SUBJECT: Withdraws 860506 request for exemption from Section IIIC of 10CFR50, App J for 16 relief valves. Justification for reverse flow testing encl. FSAR changes will be incorporated in next amend. W/two oversize charts.

July 3, 1986
(NMP2L 0768)

Re: Nine Mile Point Unit 2
Docket No. 50-410

Changes to Technical Specifications
in Area of Rod Worth Minimizer

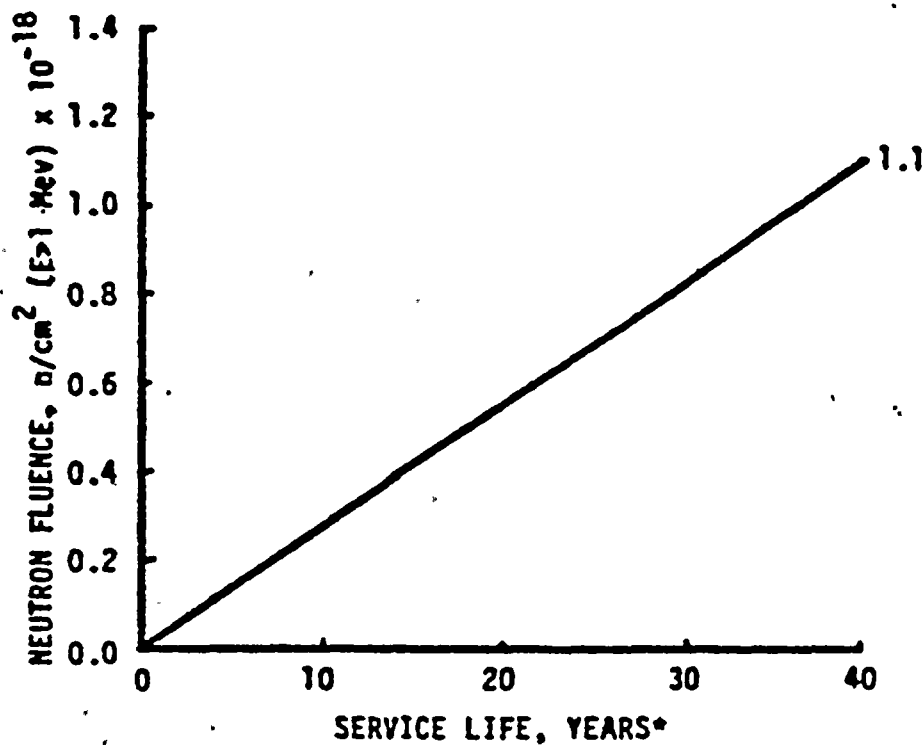
- a. With one or more of the primary containment penetration conductor overcurrent protective devices* inoperable, declare the affected system or component inoperable and apply the appropriate ACTION statement for the affected system and:
 1. For 13.8-kV circuit breakers, deenergize the 13.8-kV circuits by tripping the associated redundant circuit breaker(s) within 72 hours and verify the redundant circuit breaker(s) to be tripped at least once every 7 days thereafter.
 2. For 600 volt MCC circuit breakers, remove the inoperable circuit breaker(s) from service by opening the breaker within 72 hours and verify the inoperable breaker(s) to be in the open position at least once every 7 days thereafter.

- b. The provisions of Specification 3.0.4 are not applicable to overcurrent devices in 13.8-kV circuits which have their redundant circuit breakers tripped or to 600-volt circuits which have the inoperable circuit breaker disconnected.
